Project	IEEE 802.16 Broadband Wireless Access Working Group < http://ieee802.org/16 >	
Title	Proposed Modifications to the IEEE 802.16m SDD, Section 5	
Date Submitted	2008-03-10	
Source(s)	Yair Bourlas Lei Wang Ramon Khalona	Voice: E-mail: ybourlas@nextwave.com

Proposed Modifications to the IEEE 802.16m SDD, Section 5

Figure 1 System Reference Model

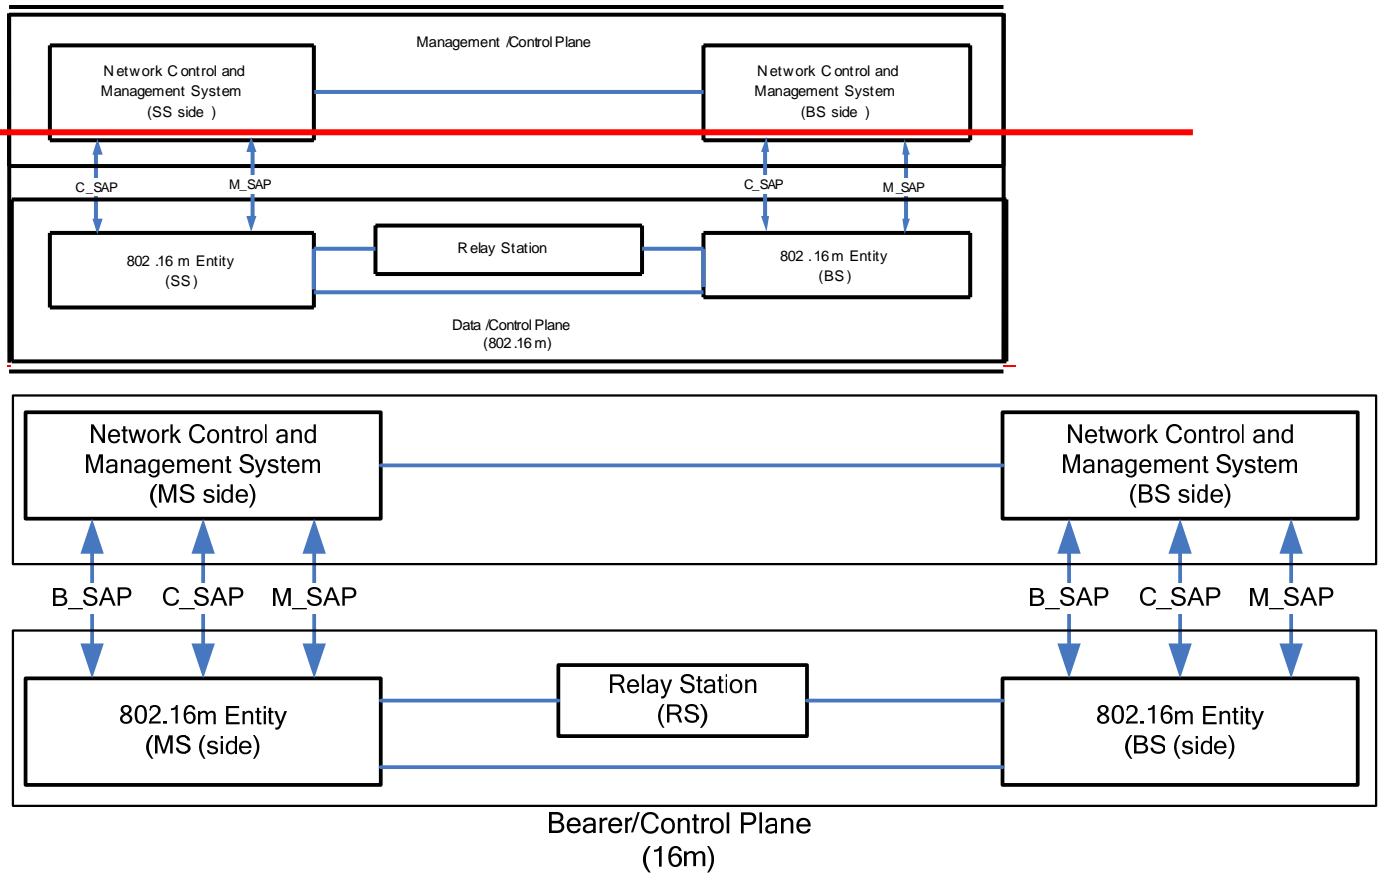
- Section 5
 - Modify Figure 3 to add Bearer SAP (B_SAP). The implication is that the 80.16m entity has the following SAPs interfacing to the upper layer entities: management SAP (M_SAP), Control SAP (C_SAP) and Bearer SAP (B_SAP). Note that we are using the term bearer instead of data SAP as it is less confusing.

A simplified reference model for 802.16 network is shown in Figure 1. An 802.16m entity is the logical entity in a SS, RS or BS that comprises the PHY and MAC layers of the [data bearer](#)/control plane. The Network Control and Management functions provide various control and management functions (including AAA, security, mobility, radio resource management, service flow management, paging and idle mode, MBS, location based services, MIH function, SS management, network management, regulatory services, multi-RAT interworking, etc.) and resides in both MS and BS. A set of SAPs provide interfaces between them and 802.16m entities.
